PLANT NAMES: Kewaunee Plant

Subject; Request for Additional Information
Your Letter of October 4, 1972

CONTAINMENT PRESSURE RESPONSE TO LOCA

COMPARTMENT DIFFERENTIAL PRESSURE ANALYSIS

Figure -2
COLD LEG BREAK STEAM FLOW PATH SCHEMATIC

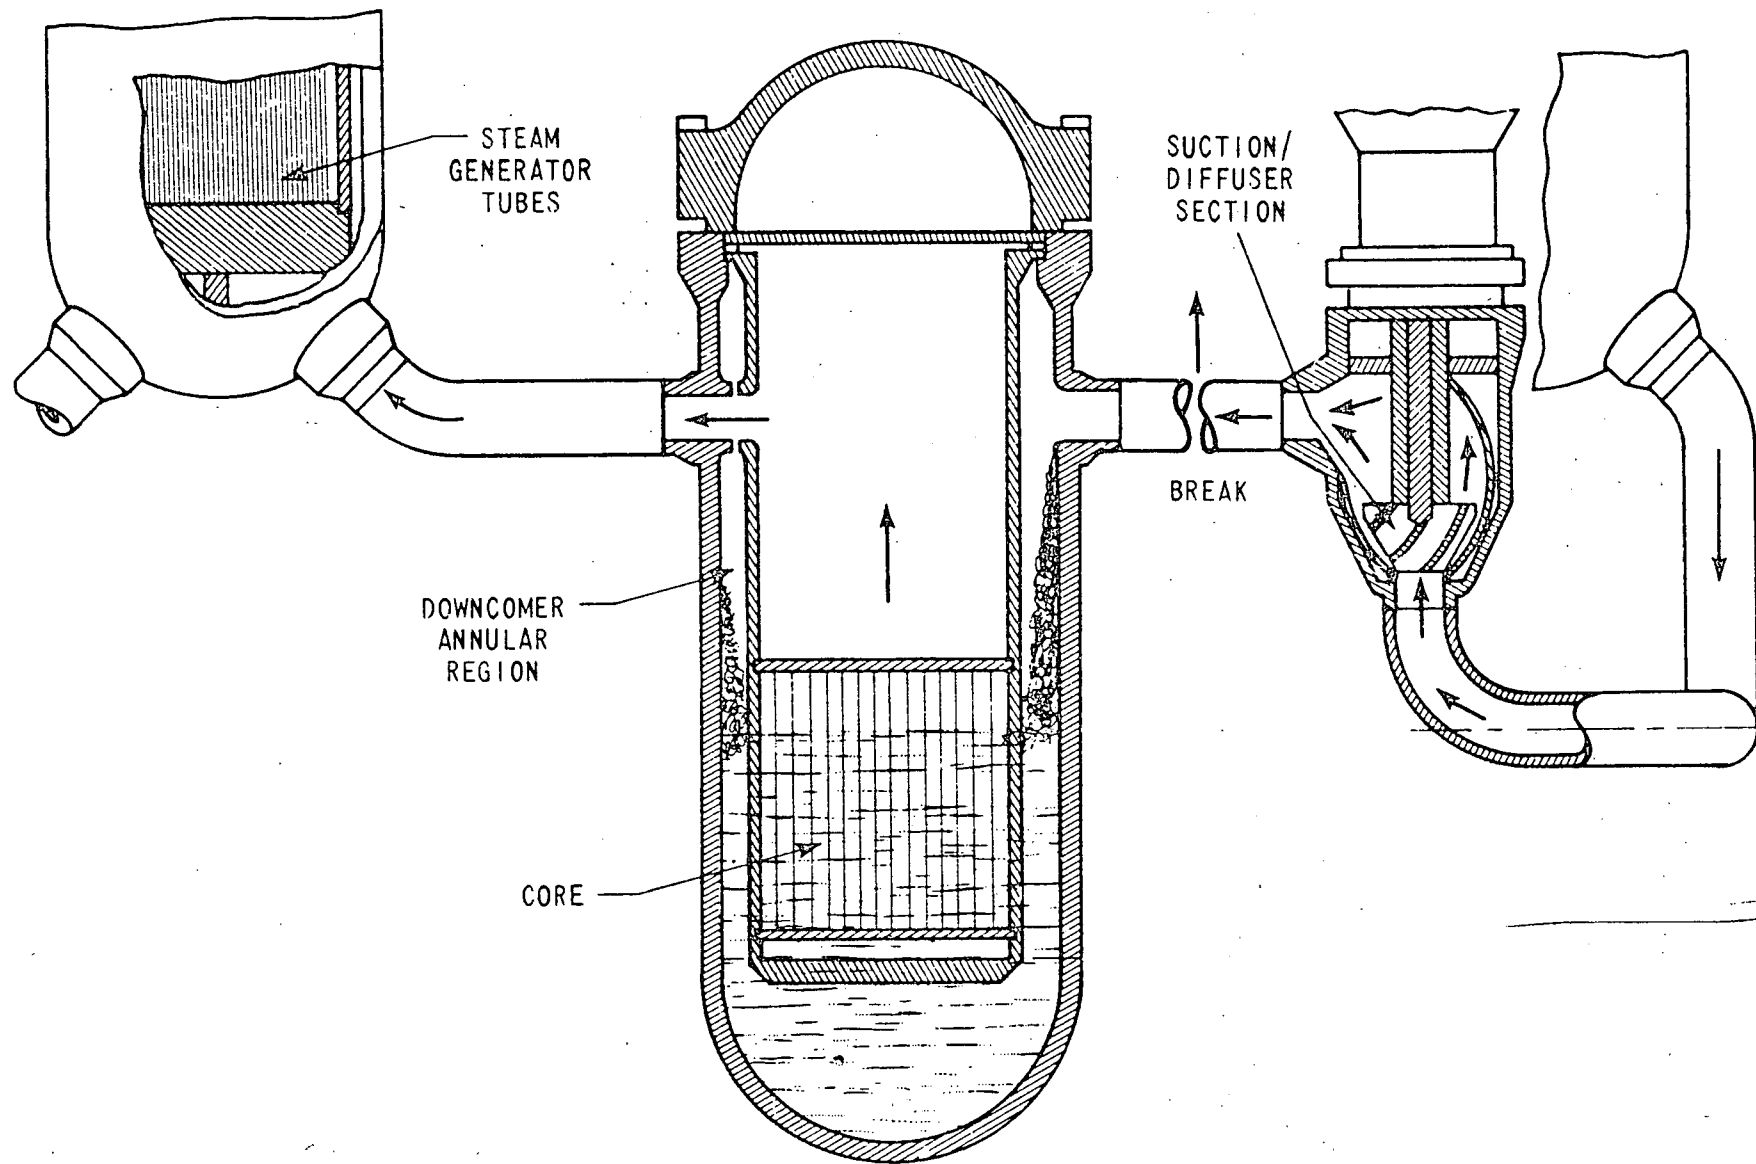
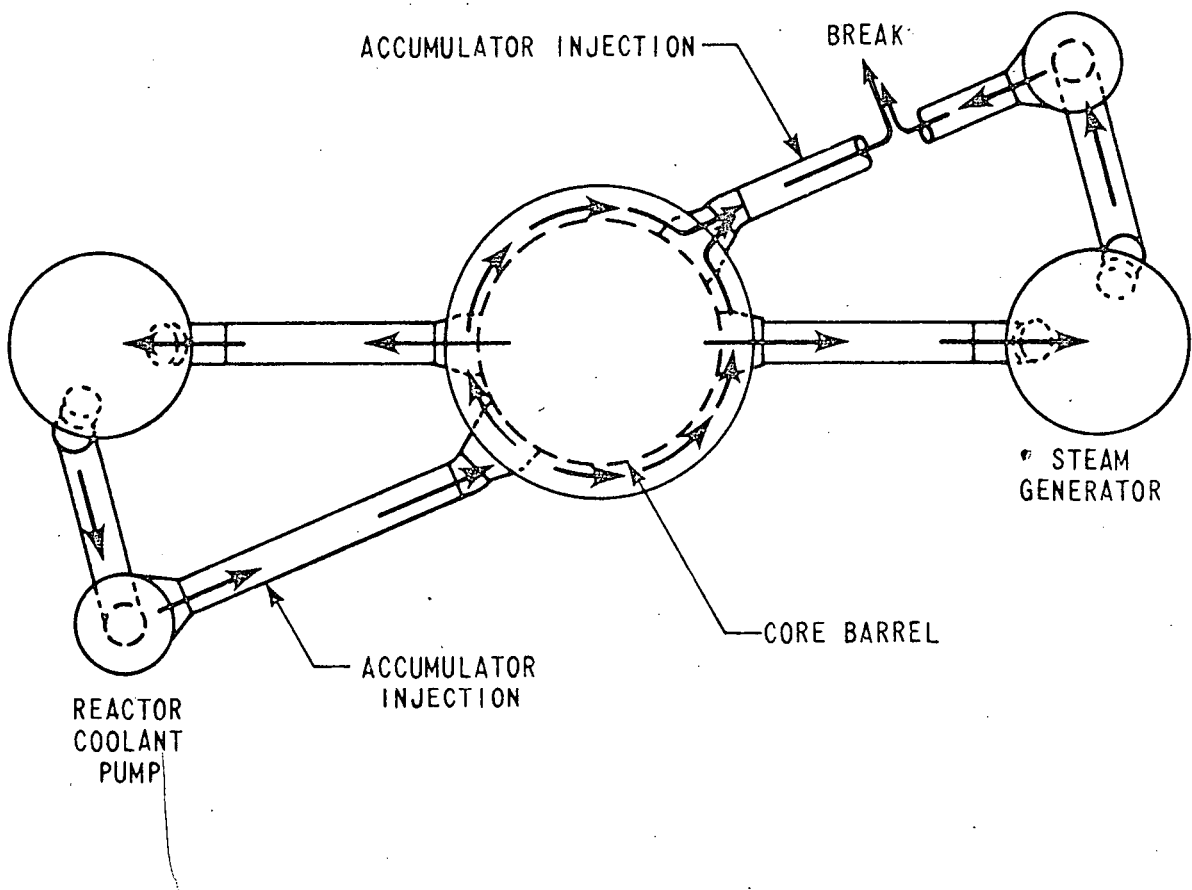
Containment pressure-time response analyses should be provided for selected design basis loss-of-coolant accidents. Double-ended breaks of the largest reactor outlet pipe and double-ended breaks of the reactor coolant pump suction and discharge pipes should be included. Smaller pipe breaks should also be analyzed and should be selected to be representative of the spectrum of break sizes for both inlet and outlet reactor coolant pipes. The analyses should be extended, as a minimum, through the blowdown, reflood and post-reflood phases of the accidents (i.e., for about 1. hour following the accident).

and finally to the break through the inlet nozzle in the broken leg. These flow paths, as depicted in Figures 2 and 3, show the path the steam must follow for the cold-leg break. The pressure drops along these two paths are calculated with the existing fluid conditions and associated loss coefficients. The pressure drop across the pump is calculated by assuming that the rotor is free spinning. In addition, it is postulated that the accumulator water injected plus the pumped injection is sufficient to maintain the downcomer full with the high calculated flooding rates. No plugging of the cold leg pipe during accumulator injection was assumed. These assumptions tend to increase the core flooding rate and the containment energy release, thus resulting in increased peak containment pressure. In the present analysis, no credit is taken for the quenching of the effect of the injection water that does not enter the core.

Figure -4 Variation in Temperature Rise, Turnaround Time, and Quench Time with Elevation

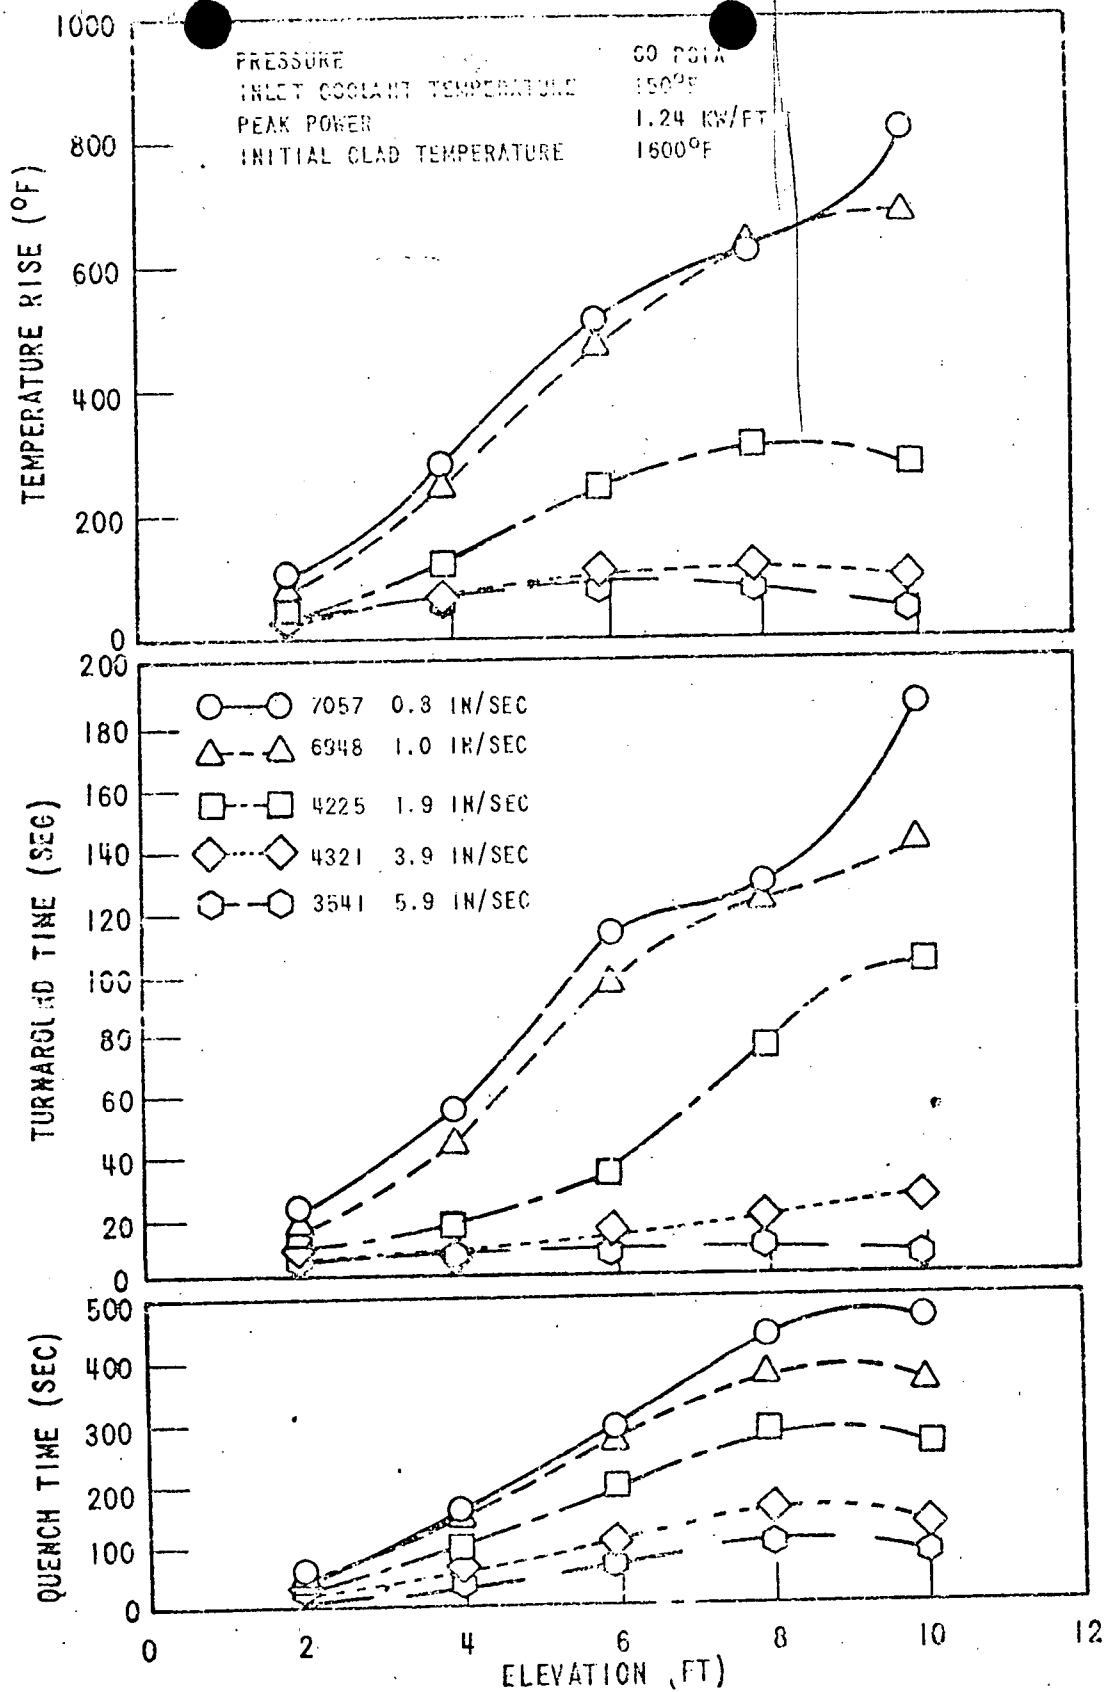
The reflood model that is used following blowdown should be described in detail. The description should include the assumptions used to develop the model, e.g., hydraulic modeling of the primary coolant system, resistances of components (primary coolant pump, steam generator, piping and reactor core), and the methods used in computing steam generation in the core and other energy sources (core stored energy, decay heat [short and long term] thick and thin metal-stored energy, and steam generator-stored energy).

From FLECHT data, it is found that entrainment begins after the level in the core rises 20 inches. It continues until the entire core is quenched. The FLECHT data shows that by the time the 8 ft. elevation is quenched by the rising water level, the 10 ft. elevation has already been quenched. This is shown in Figure-4. In the present analysis, it has been conservatively assumed that entrainment continues until the quench front reaches the 8 ft. elevation. The sensitivity of this assumption is evaluated by sensitivity studies.
